FIELD SERVICE BULLETIN

FIELD SERVICE BULLETIN NO. 21
5 August 1954

SUBJECT: RELATIVE MOTION BETWEEN FUSELAGE AND WINGS

EFFECTIVITY: ALL NAVION AIRCRAFT (MANDATORY)

AFT WING ATTACHMENT FIG. 1

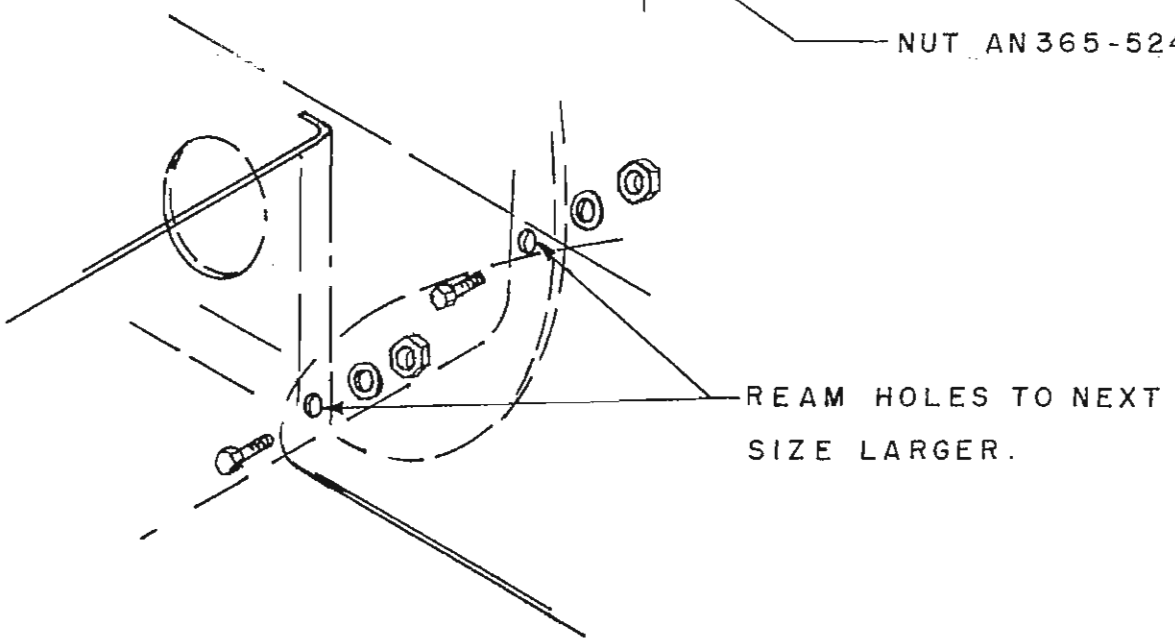
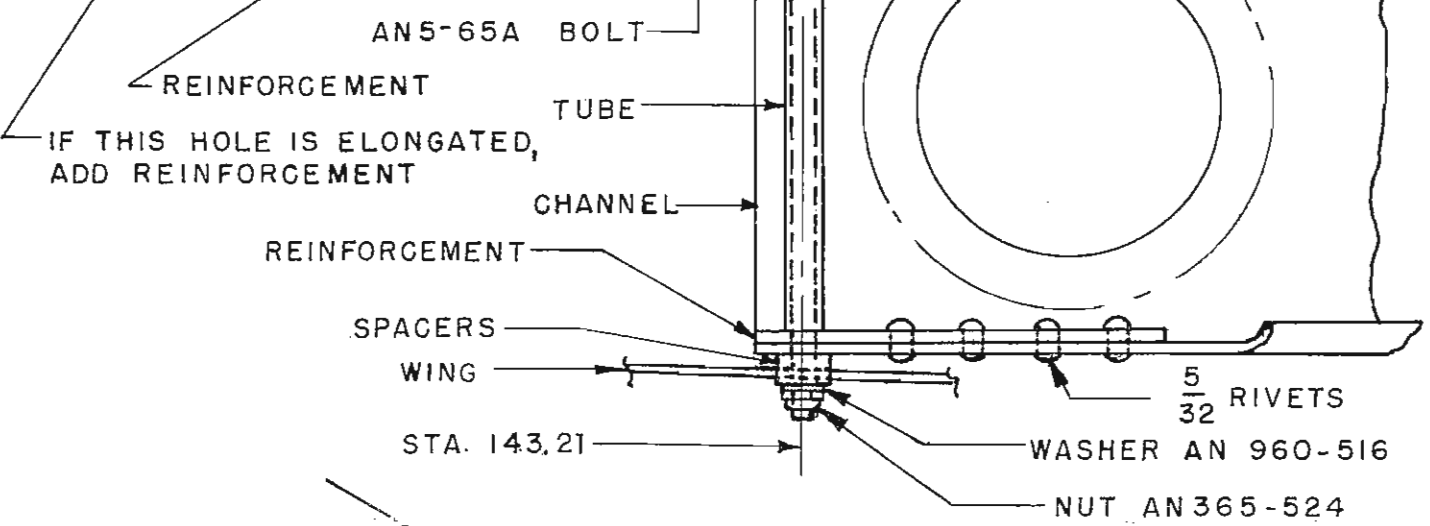
- e. Where elongated holes are evident proceed as follows.
- f. Ream holes of the four forward wing attachments to receive the next larger size bolts. Remove and replace ONLY one bolt at a time and torque to 140 inch pounds (see Figure 2).
- g. Remove the two AN5-65A aft attachment bolts, spacers, washers, tubes and nuts.
- h. Drill and attach the two .064-24ST alclad strips (see Figure 1), one on each end of the bottom inside flange of frame 142.57 and rivet each strip with four 5/32 inch rivets.
- i. Shorten the two tube spacers to fit within the channel.
- j. Install two AN5-65A bolts with nuts, washers, spacers and tubes. Torque to 140 inch pounds.
- k. Drill top wing skin at fifteen places parallel to longeron on each side of cockpit, and blind rivet the right and left .064-24ST alclad angle in place (see Figures 3, 4, 5 and 6).

FIG. 3

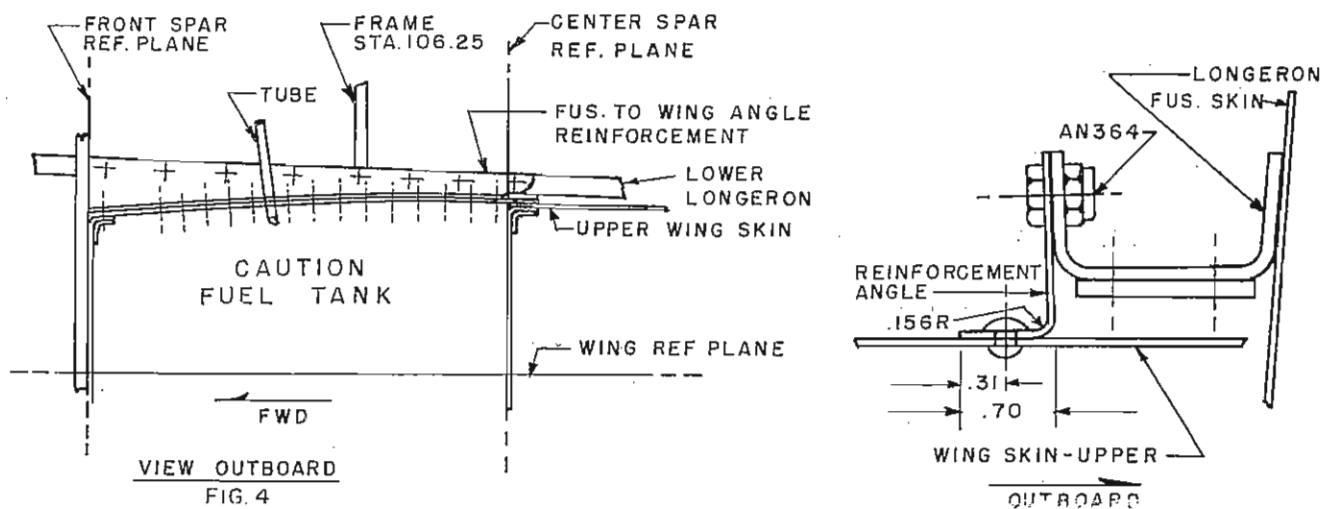
- l. Drill eight 3/16 inch holes in fuselage longerons and attach angles with AN3 bolts and AN364 nuts. Add shims between longeron and bathtub fitting on forward bolt if necessary (see Figures 3, 4, 5 and 6).
 - m. Reinstall side upholstery panels, floor mat and seats.
 - n. Attach fuel filter inspection plate and wing fillets.
4. Parts may be locally manufactured from information furnished in this bulletin or procured in kit form at nominal cost from
